**Village Review Response Memorandum:**

**Project: Stonecast Off-Site Storage**

**Comments Received: 1-5-2023**

**Plans Reviewed:**

**SOUTH PARTIAL  
 SITE GRADING PLAN C2.2**

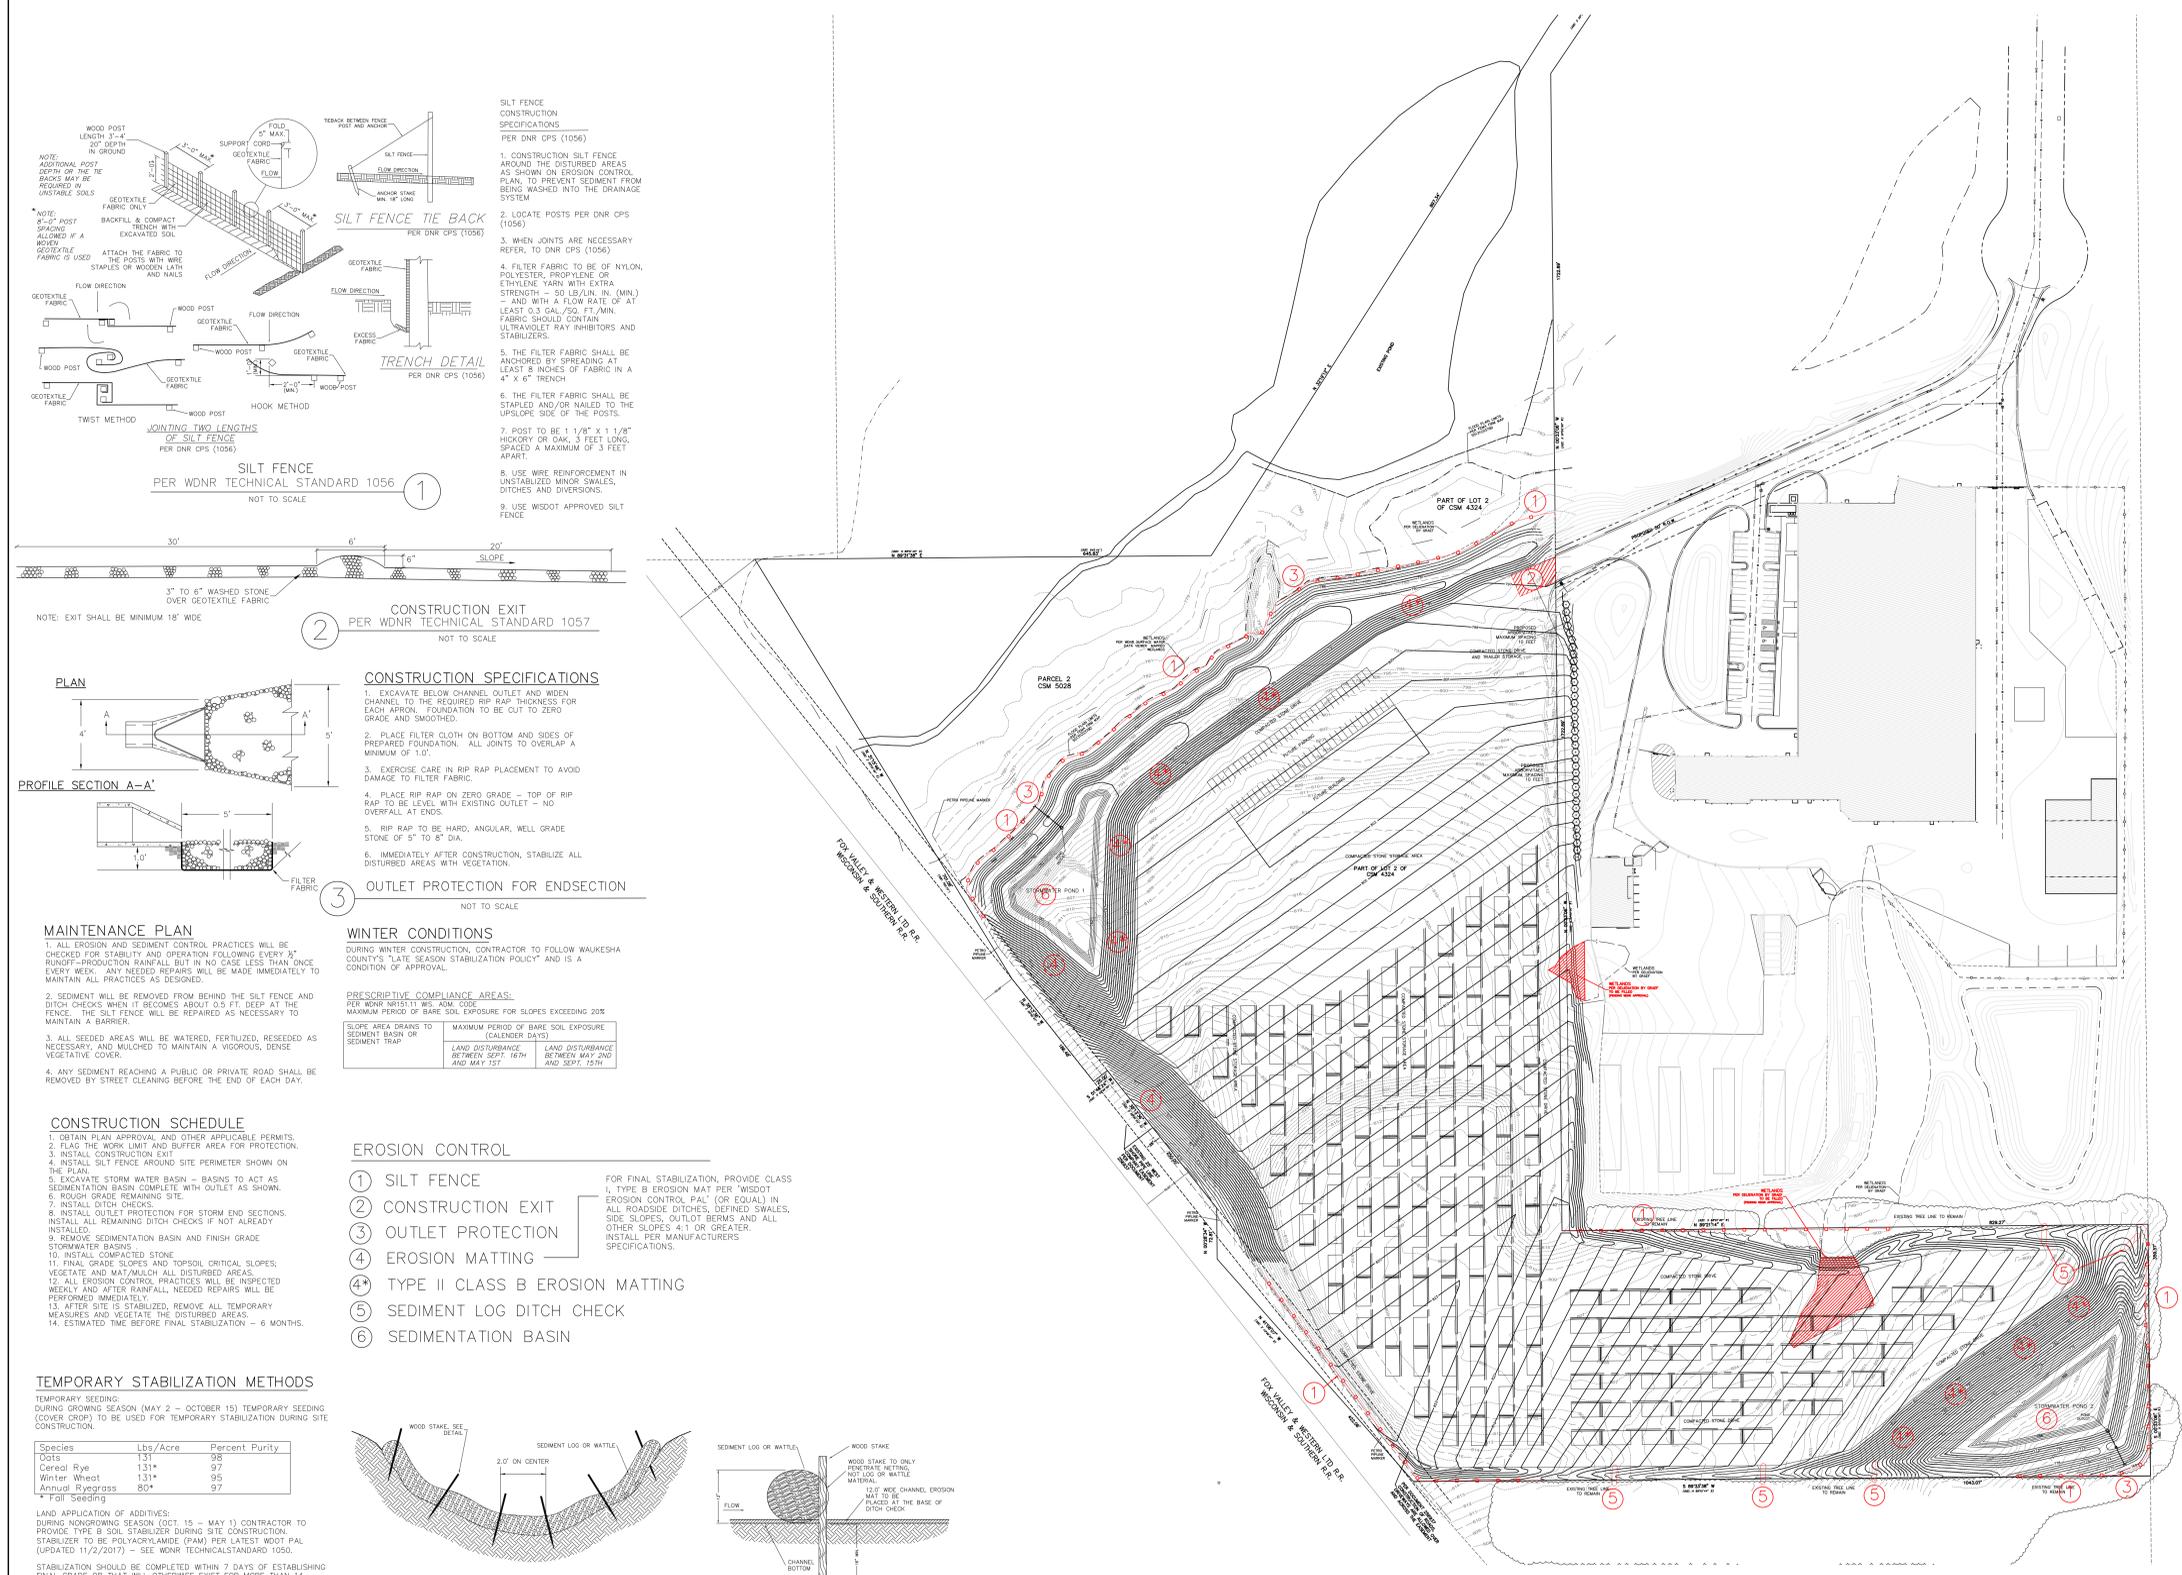
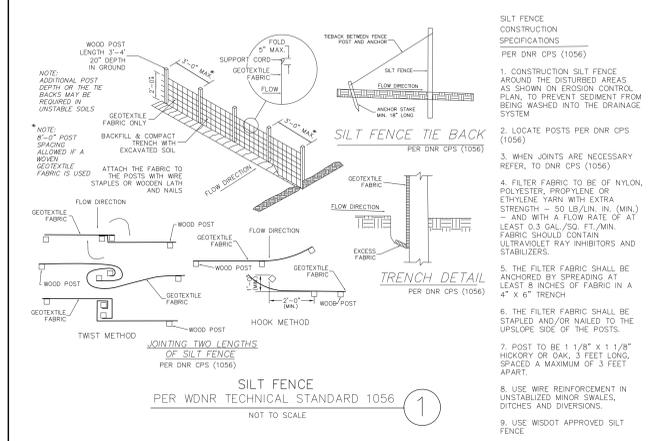
7. The plans indicate a gas pipeline traversing the property east of the railroad (by way of the note "Petro Pipeline Marker"). The grading plan on sheet C2.2 indicates that grading/filling will be done as close as 10'-15' from that pipeline. Is there an easement within which that pipeline is located? If so, the easement location should be shown on the plans. More importantly, has the operator (I believe TC Energy-ANR Pipeline) been contacted and your plans discussed? If so, is/are there any requirements or stipulations affecting the proposed project? *Response: The pipeline easement has been shown on the revised plan set based on document 256937. This document has been provided for reference. Document states that construction of roads, driveway s and railways is permitted over the easement.*
